Addendum #6

Bid Opportunity: CPS-RFT-25-03 - North Paris Fire Station

PROJECT: North Paris Fire Station

ADDENDUM 02

E104

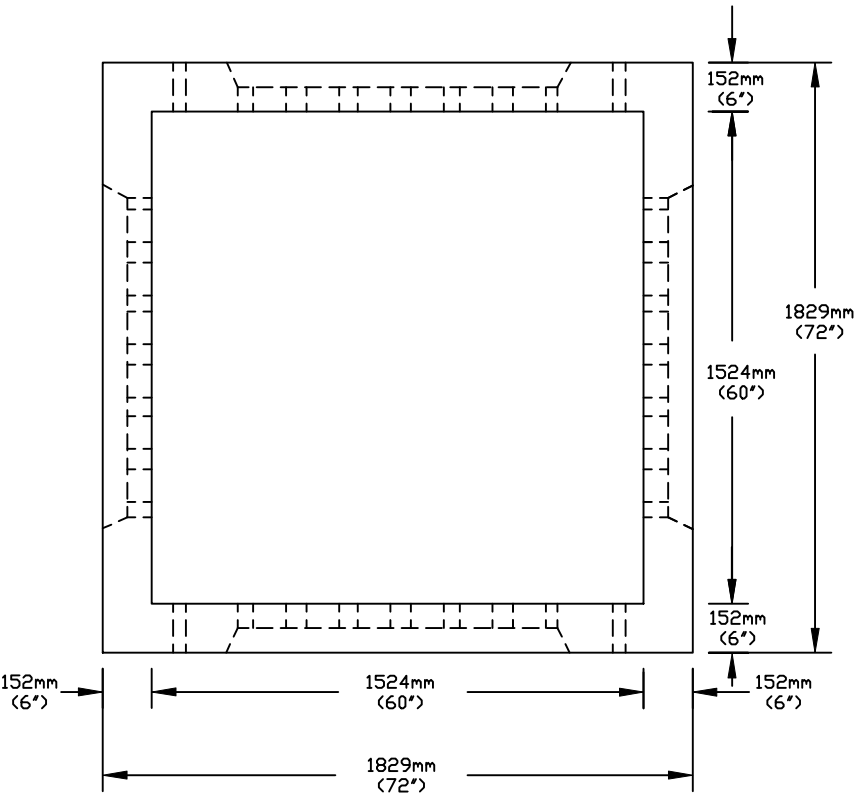
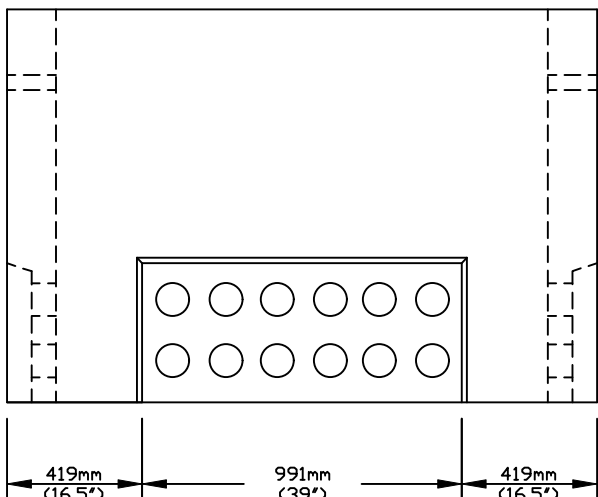
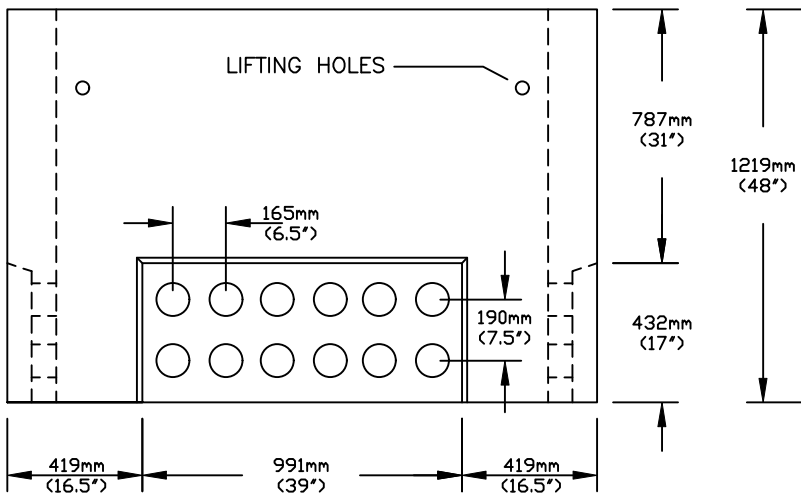
- 5.0 Reference Attached Reissued Drawing E104
- .1 In the light fixture schedule revise to equals for fixture types 'L3', 'L5', 'L7', 'L7A', and 'L11' as per attached reissued drawing E104.

TITLE: PRECAST CONCRETE ENCLOSURE FOR THREE PHASE PADMOUNT TRANSFORMER UP TO 1000KVA		
DATE: NOV./93	SCALE: N.T.S.	W.O.No.: DRAWN BY: R.S.
DESIGNED BY	APPROVED BY P.ENG.	DRAWING No. UGS-029

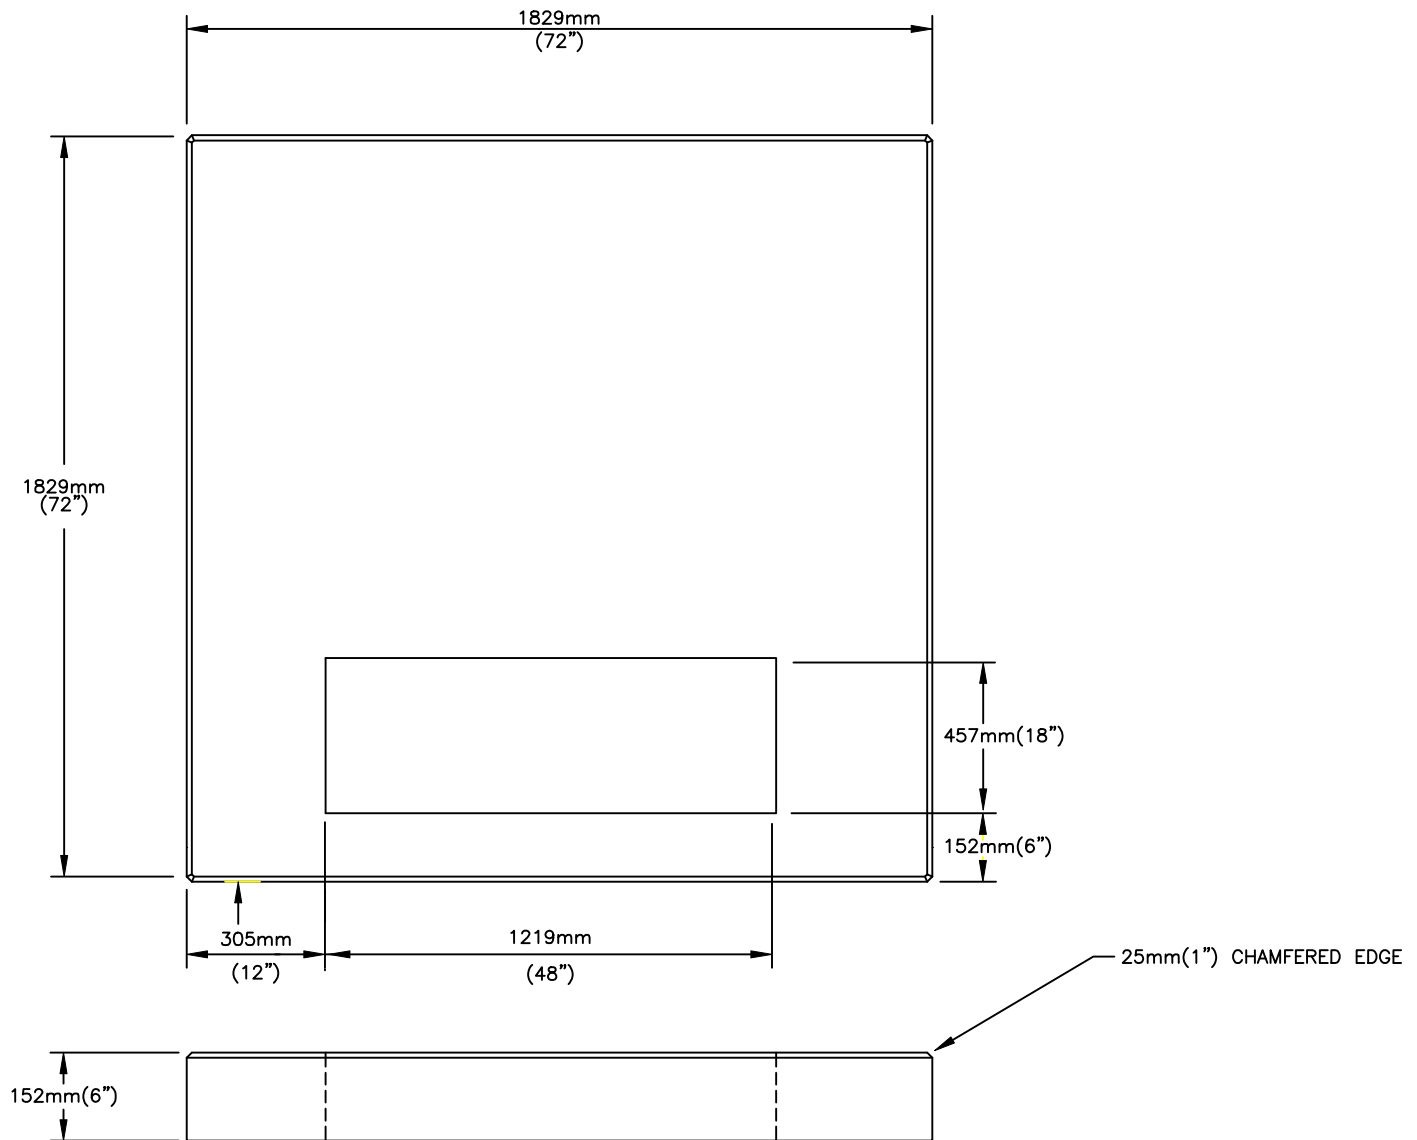
- 4.0 Reference Attached Reissued Drawing E102 and Grandbridge Energy vault details UGS-029 and UGS-029a
- .1 In Detail 'H' (3PH Pad Mounted Transformer Grounding) the approved concrete foundation suppliers delete and replace with "APPROVED CONCRETE FOUNDATION TO BE 192C-SP UGS-033 (OUR 040-0967) OR AS APPROVED BY GRANDBRIDGE ENERGY."
